ALBA BEACH SUBDIVISION, **RESUBDIVISION OF LOT 17**

APPLICATION NUMBER 7 DATE October 20, 2016

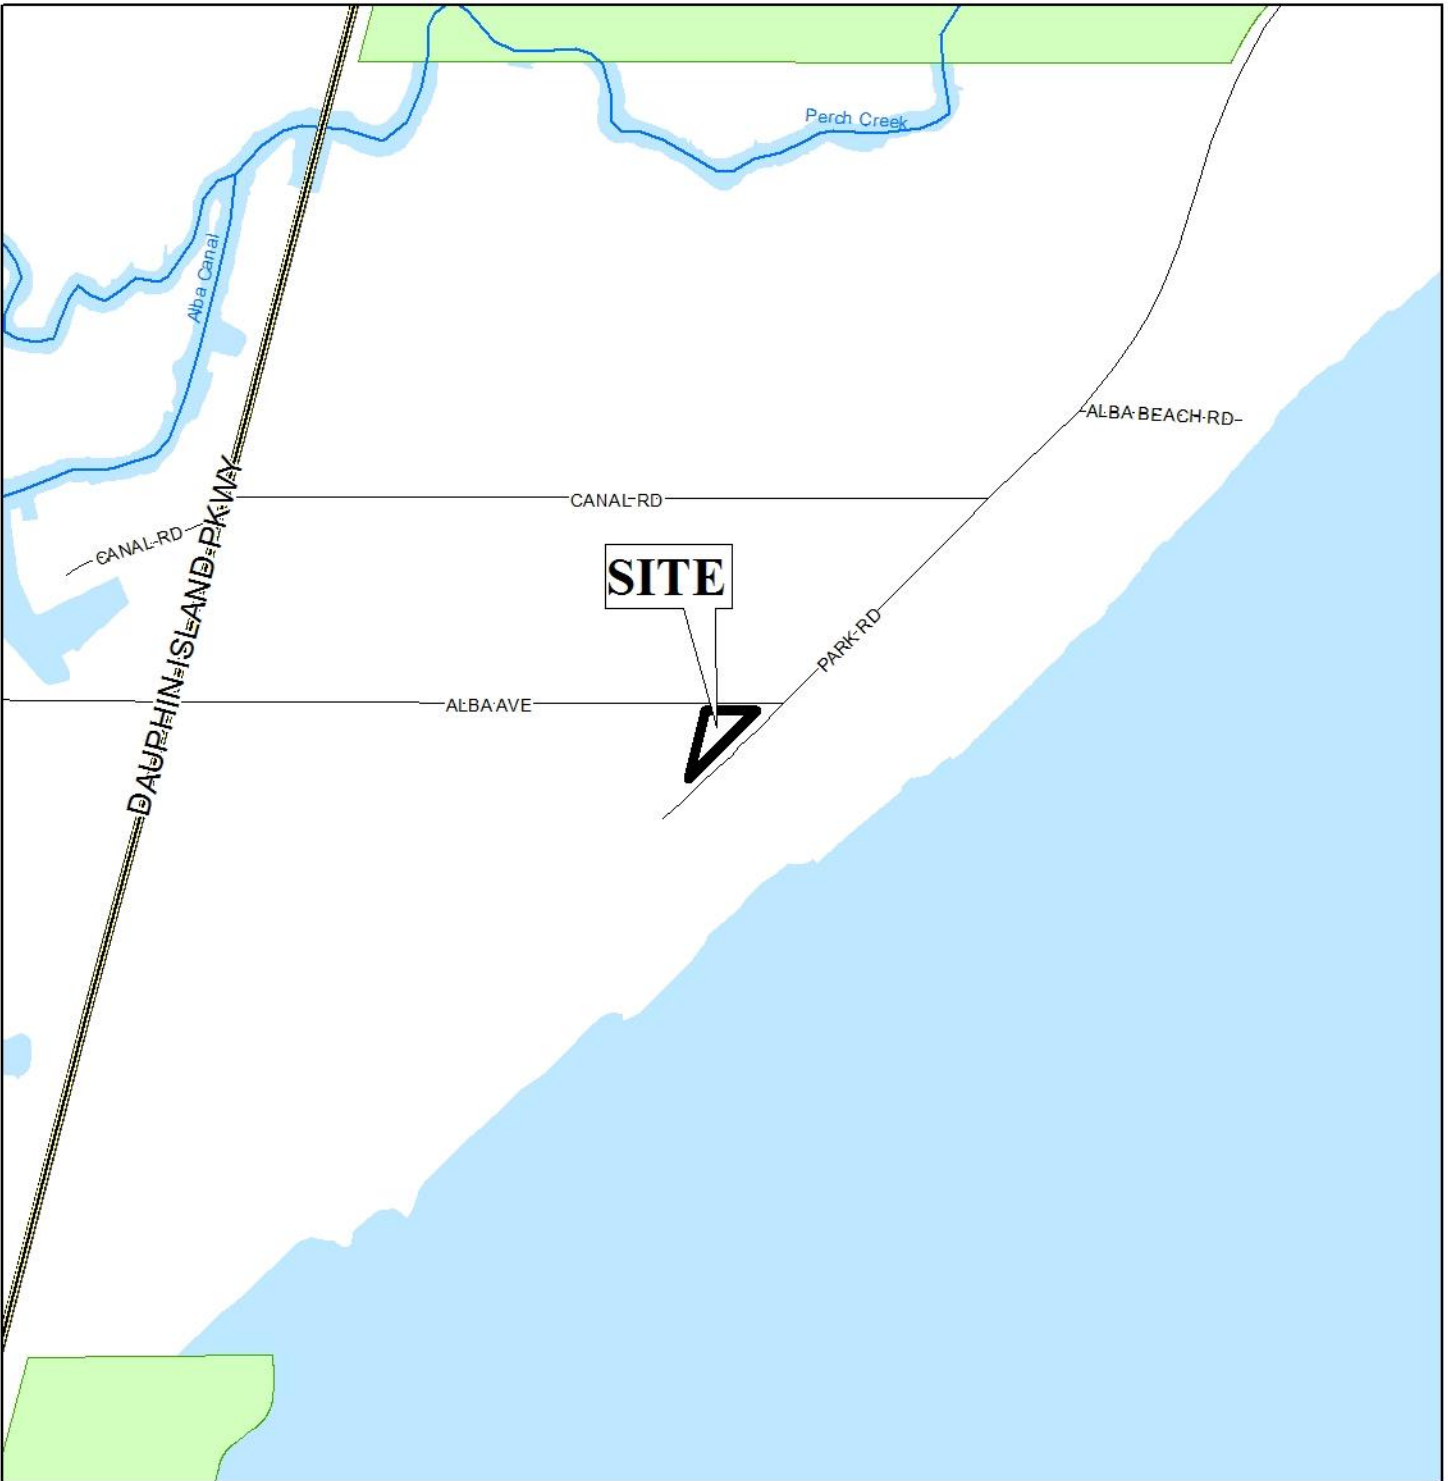
The plat illustrates the proposed 1-lot, 0.3± acre subdivision which is located at the Southwest corner of Alba Avenue and Park Road within Council District 3. The applicant states that the subdivision is served by city water and sanitary sewer systems. The purpose of this application is to create one legal lot of record from one metes-and-bounds parcel.

The subject site fronts both Alba Avenue and Park Road, which are paved minor streets without curb and gutter. As paved minor streets without curb and gutter, these streets require a 60' wide right-of-way. The right-of-way widths for Alba Avenue and Park Road are depicted as 50' wide and 40' wide, respectively, on the preliminary plat. An approval in February 2011 by the Planning Commission for a site across Park Road only required dedication sufficient to provide 25' from the centerline, thus, the Final Plat, if approved, should be revised to reflect dedication sufficient to provide 25' from the centerline of only Park Road.

The 25-foot minimum building setback line is depicted on the preliminary plat along Alba Avenue and Park Road, and if approved, should be retained on the Final Plat, adjusted for any required dedication.

The proposed lot exceeds the 7,200 square foot minimum lot size requirements for lots served by public water and sanitary sewer systems; however, if approved, the Final Plat should be revised to indicate the lot size information in both square feet and in acres, adjusted for dedication.

As a means of access management, a note should be placed on the Final Plat stating that the site is limited to the existing curb cut to Alba Avenue and one curb cut to Park Road, with any changes to the size, location and design to be approved by Traffic Engineering and conform to AASHTO standards.

Based upon the preceding, this application is recommended for Tentative Approval, subject to the following conditions:

- 1) Dedication sufficient to provide 25' from the centerline of Park Road;
- 2) Retention of the 25' minimum building setback line along Alba Avenue;
- 3) Retention of the 25' minimum building setback line along Park Road;
- 4) Revision of the Final Plat to provide the lot size information in both square feet and in acres;

- 5) Placement of a note on the Final Plat stating the site is limited to the existing curb cut to Alba Avenue and one curb cut to Park Road, with any changes to the size, location and design to be approved by Traffic Engineering and conform to AASHTO standards;
